*STP-209-1(2) Roadway and BHF-209-1(3) Bridge  
Widening of SR 74 From SR 85 to*

*P.I. Nos. 322355 and 322357*

**Value Engineering Study Report**

Preliminary Design Stage

K-

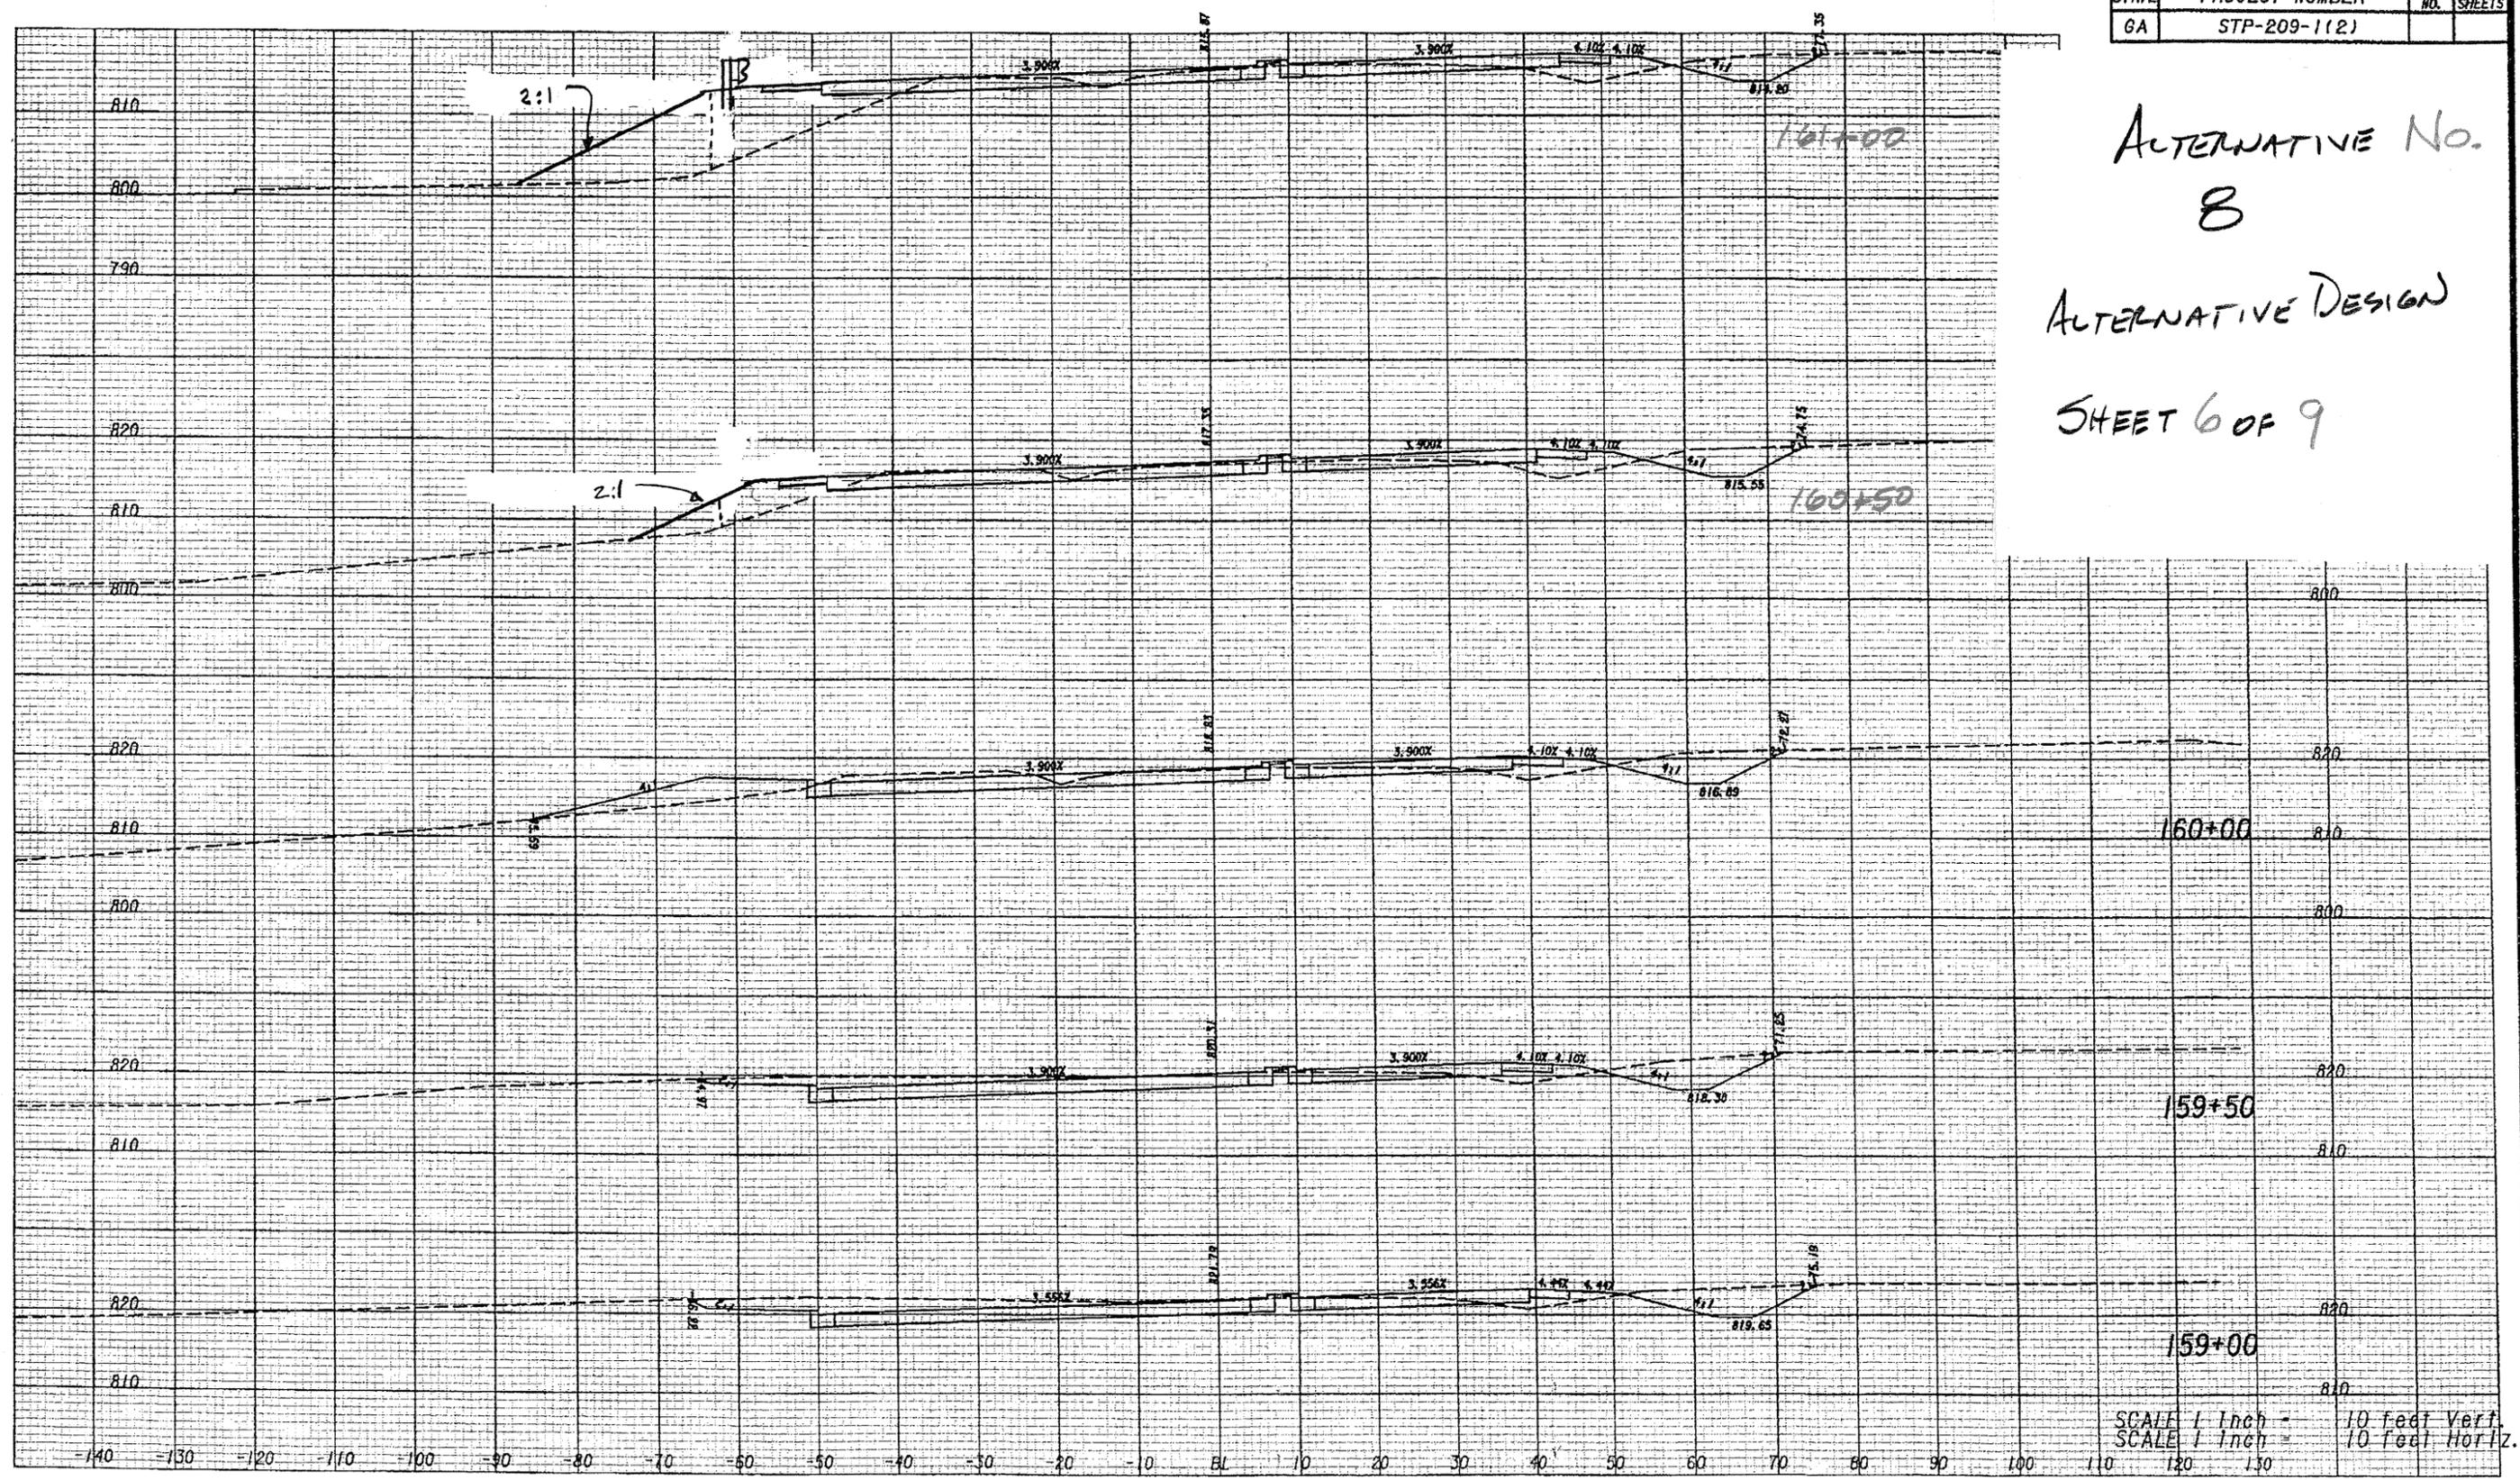
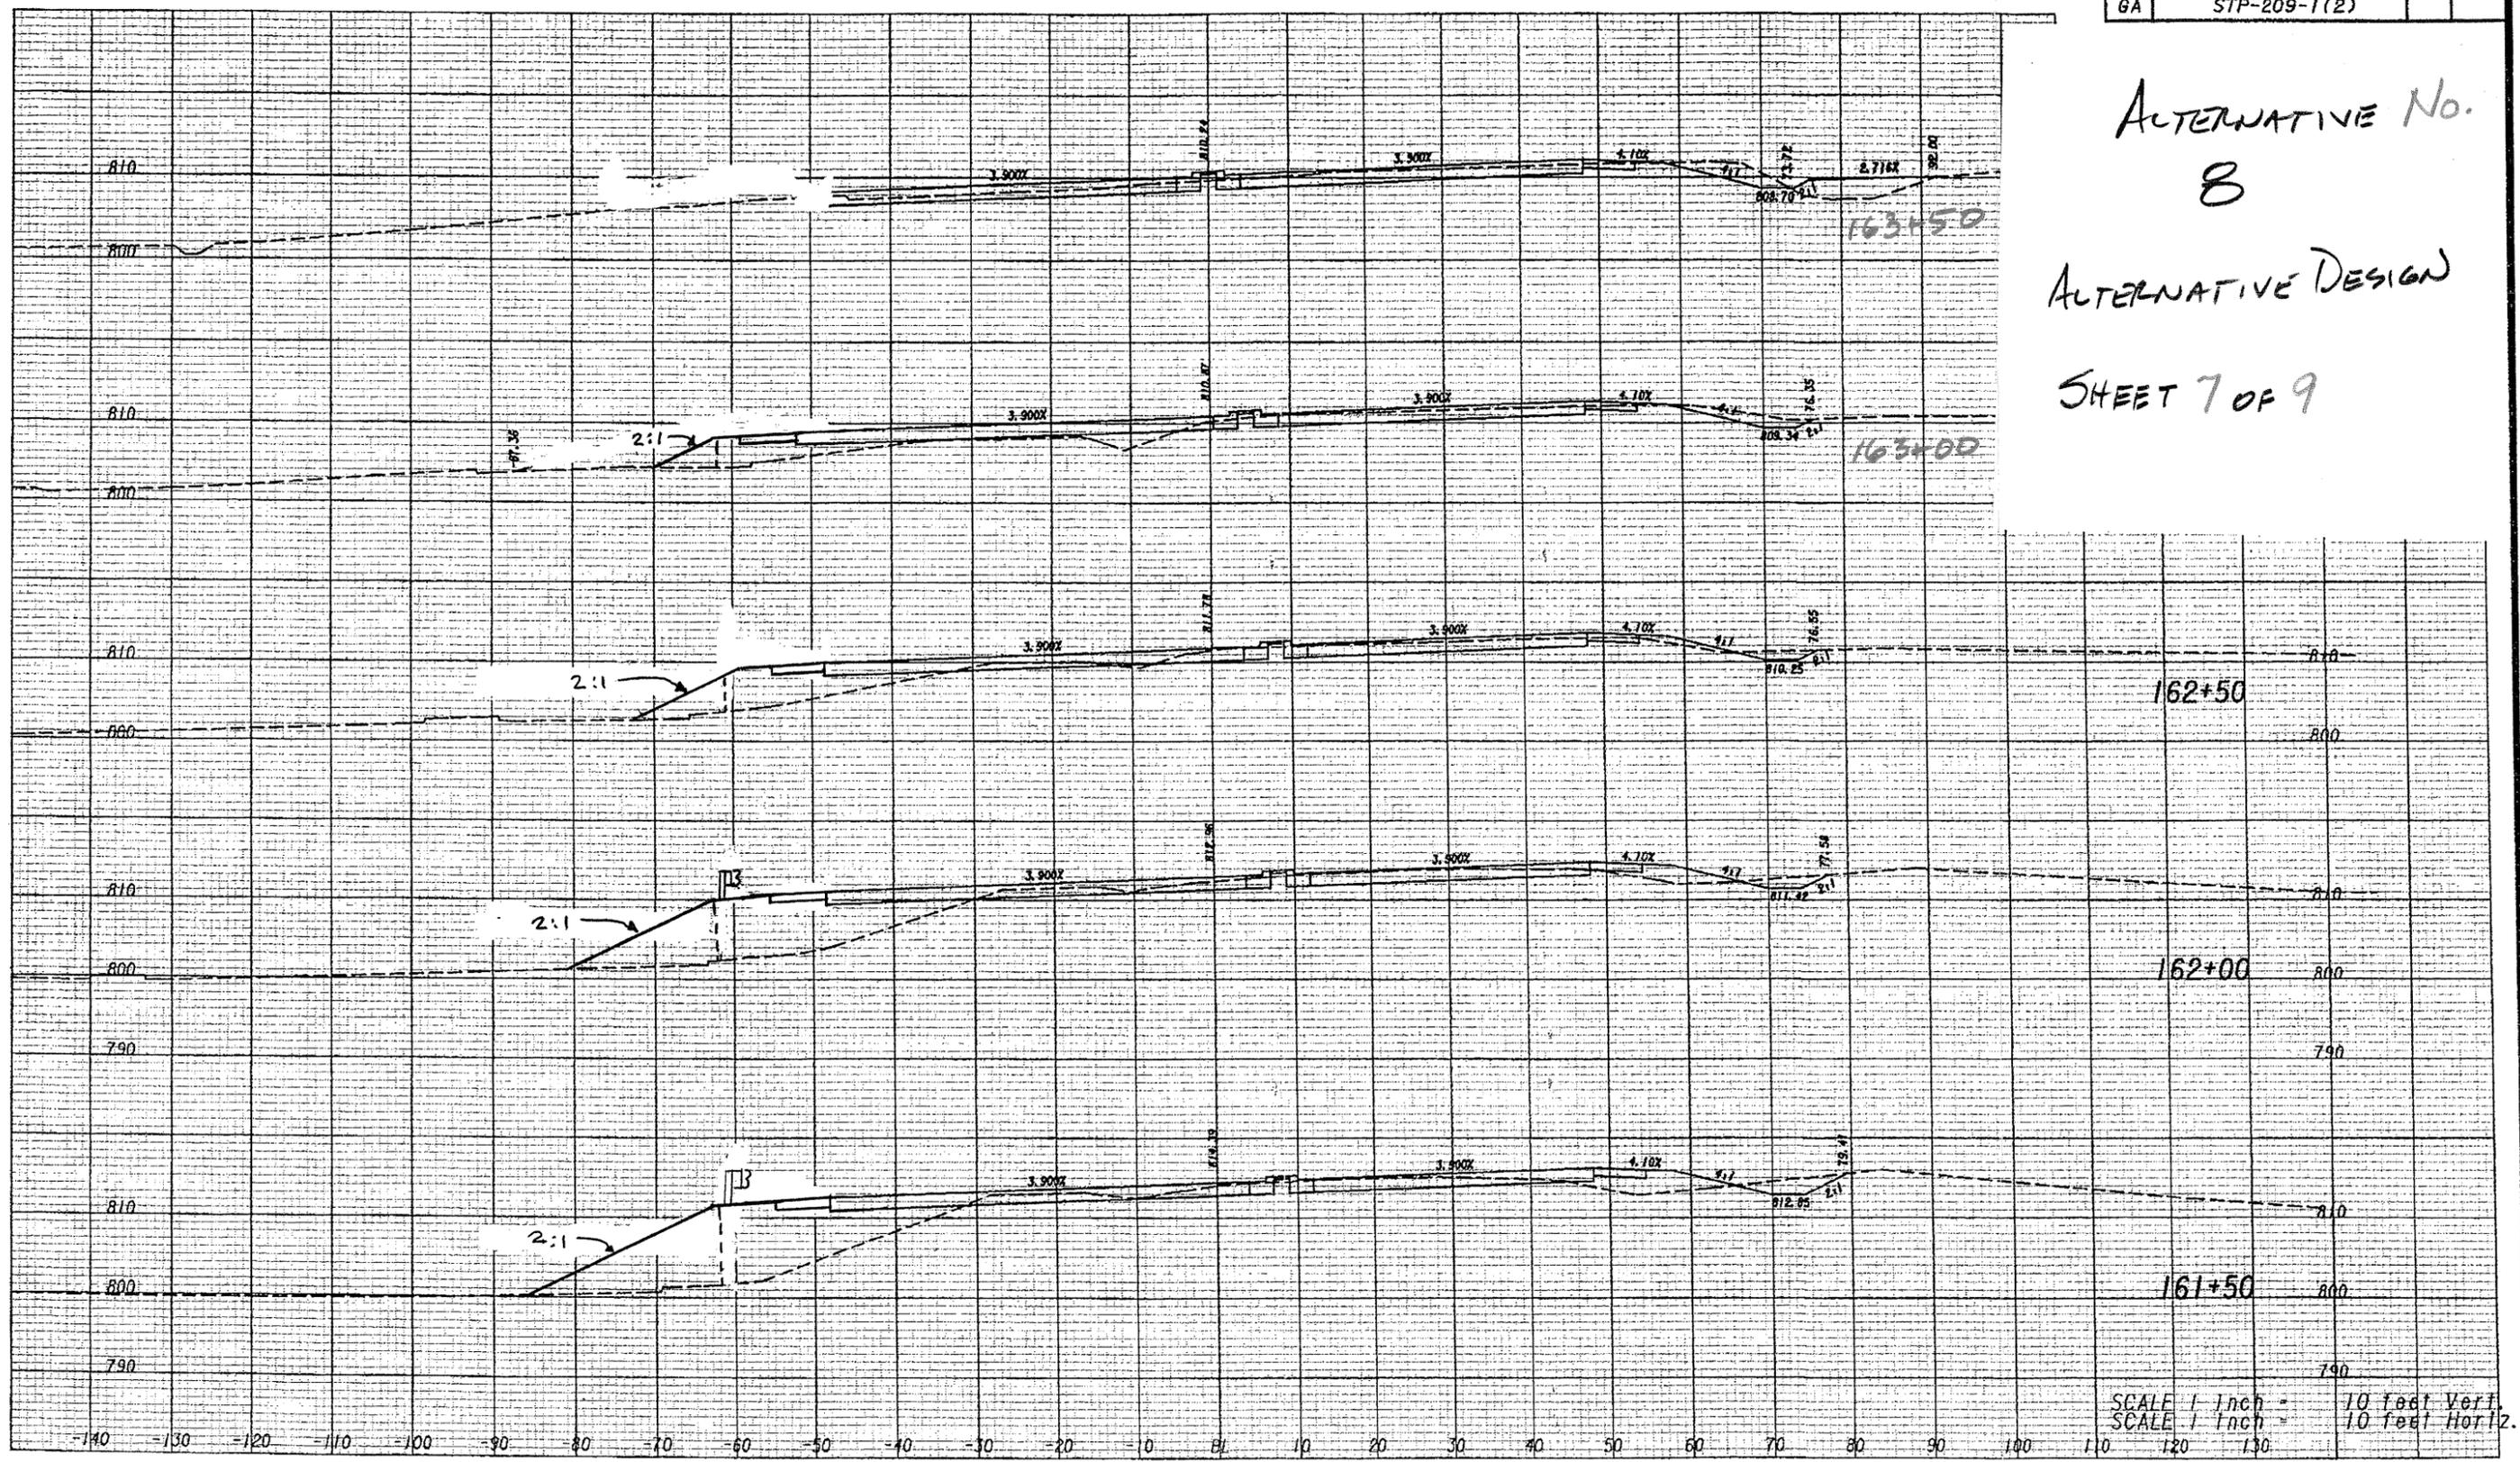
DESCRIPTION: **ELIMINATE THE RETAINING WALL AND PROVIDE** SHEET NO.: **1 of 9**  
**ADDITIONAL DAYCARE PARKING**

Replace the retaining wall with a 2:1 fill slope and provide five additional parking spaces.

PROVIDE  
5 PARKING  
SPACES
